Docket 50-305
 Operating License DPR-43
 Kewaunee Nuclear Power Plant
Generic Implication of Salem ATWS Event (Generic Letter 83-28)

This letter provides the information requested by members of your staff concerning the preliminary design report describing the conceptual design of the Kewaunee Nuclear Power Plant's (KNPP) implementation of the shunt trip modification.

DB-50 REACTOR TRIP SWITCHGEAR
AUTOMATIC REACTOR PROTECTION
SYSTEM TRIP VIA THE SWITCHGEAR
SHUNT COIL TRIP ATTACHMENT

WISCONSIN PUBLIC SERVICE CORPORATION
KEWAUNEE NUCLEAR POWER PLANT

FIGURE 1 of 3

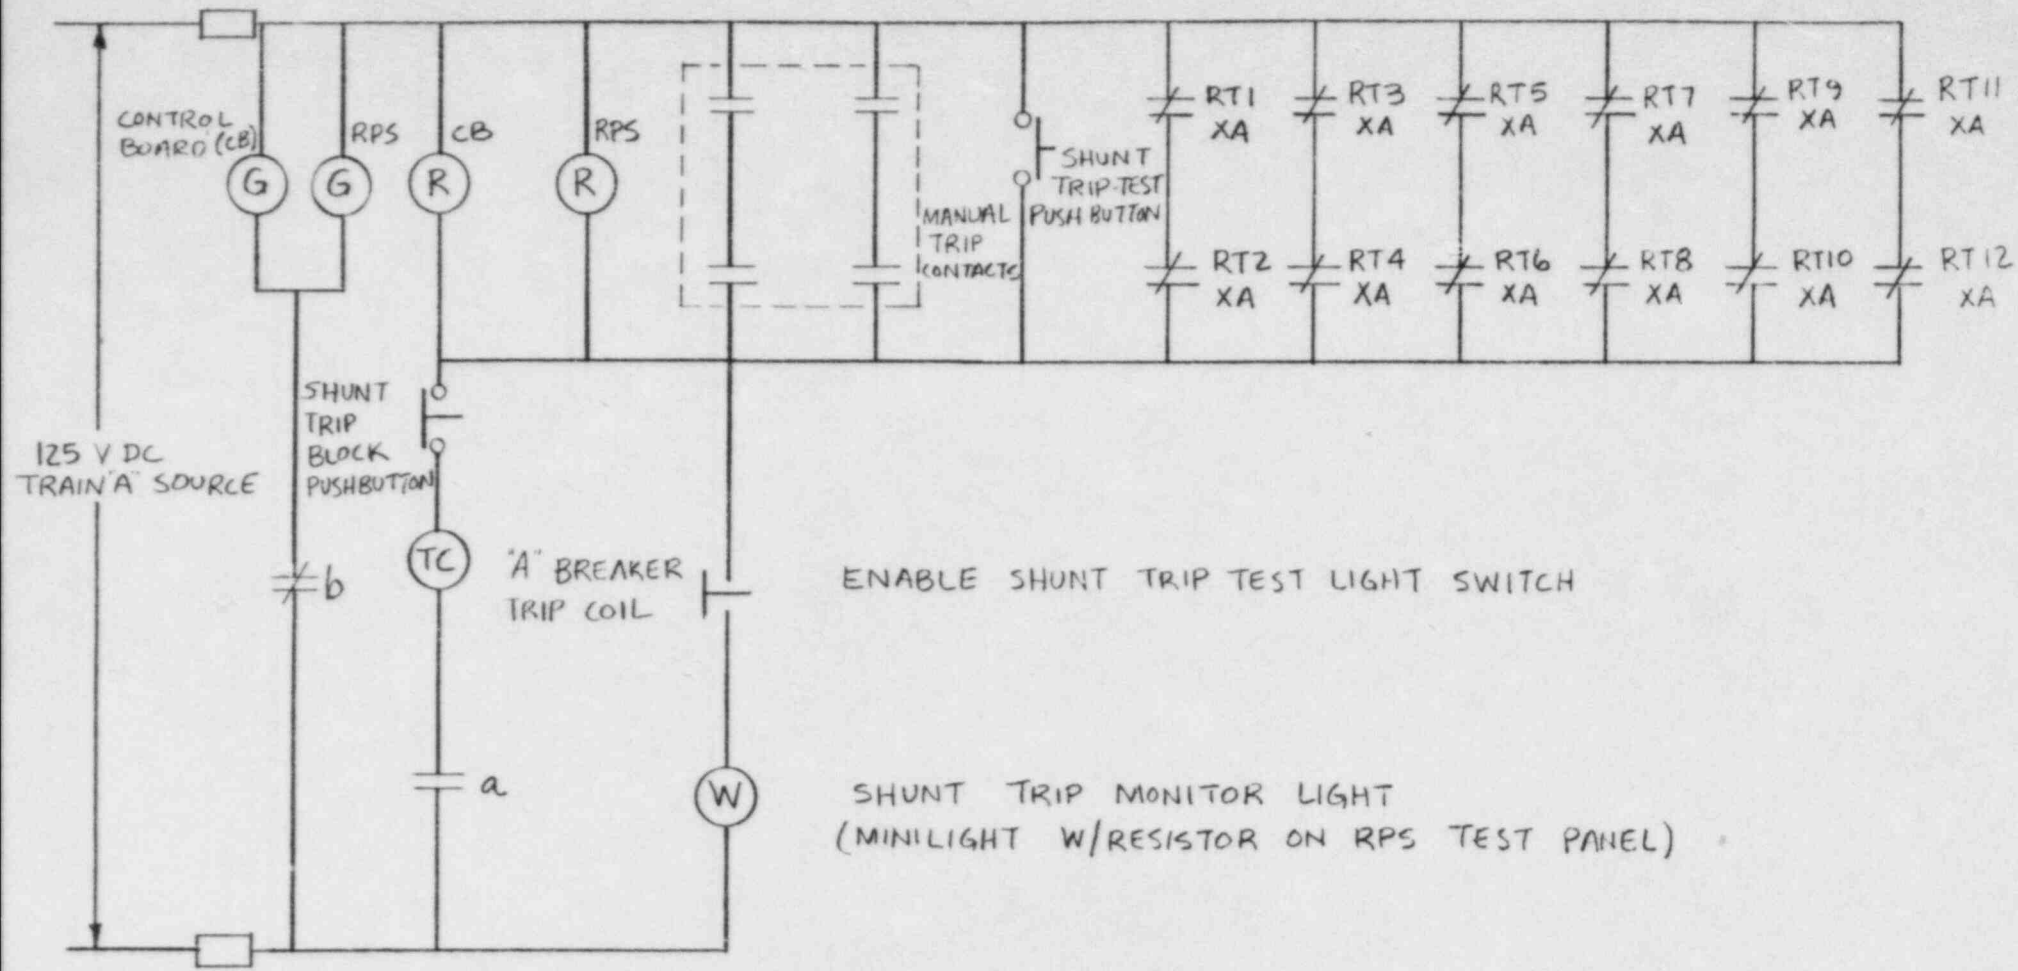
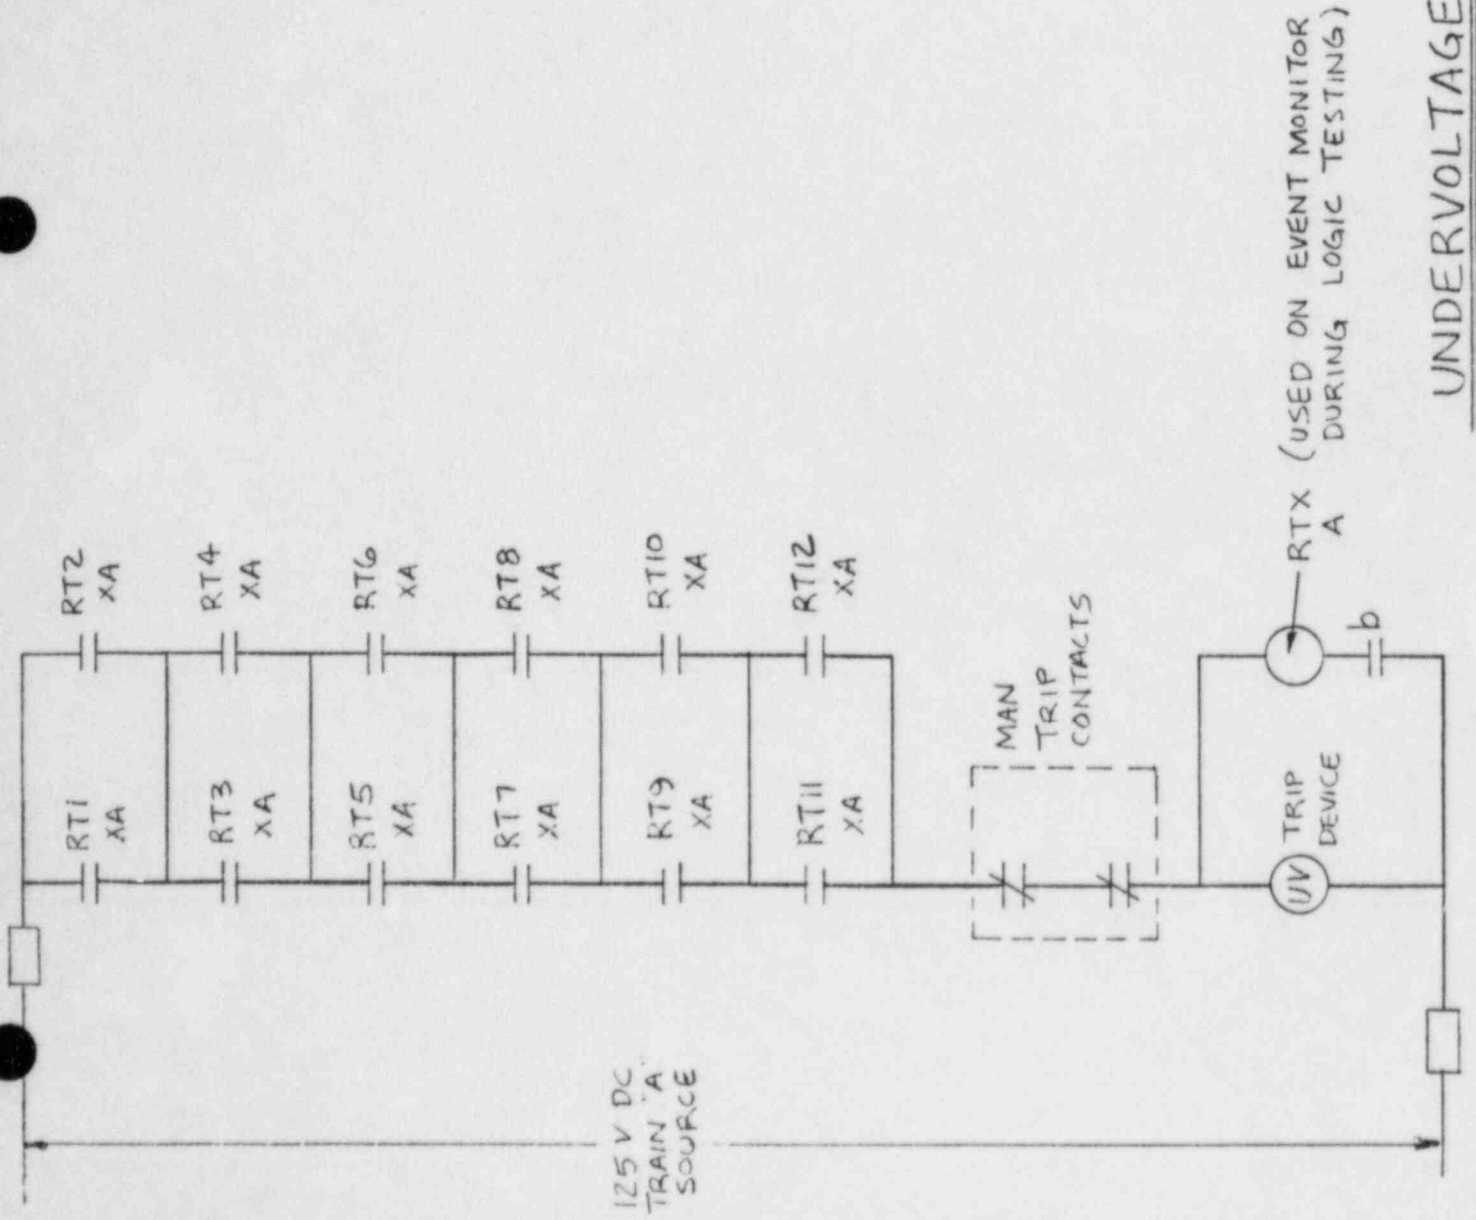
Provide the electrical schematic/elementary diagrams for the reactor trip and bypass breakers showing the undervoltage and shunt coil actuation circuits as well as the breaker control (e.g., closing) circuits, and circuits providing breaker status information/alarms to the control room.

The attached figures show the modification for breaker RTA. The same modification is required for RTB. A logic matrix, which is the energize-to-trip equiva-

lent to the ladder matrix used on the undervoltage trip, is developed using spare contacts on the reactor protection relays. No additional relays are installed for this design. Two test pushbuttons along with a monitor light and switch are installed on the reactor protection test panel. When an anticipated transient occurs, contacts open in the ladder matrix to deenergize the undervoltage coil. Simultaneously contacts close in the new logic matrix to energize the shunt trip coil. Thus the trip bar of RTA will be actuated by both the UV and shunt trip devices. The two test pushbuttons, monitor light and switch are used during testing to individually confirm the operability of the UV trip and the shunt trip.

The attached three figures show the proposed modification.
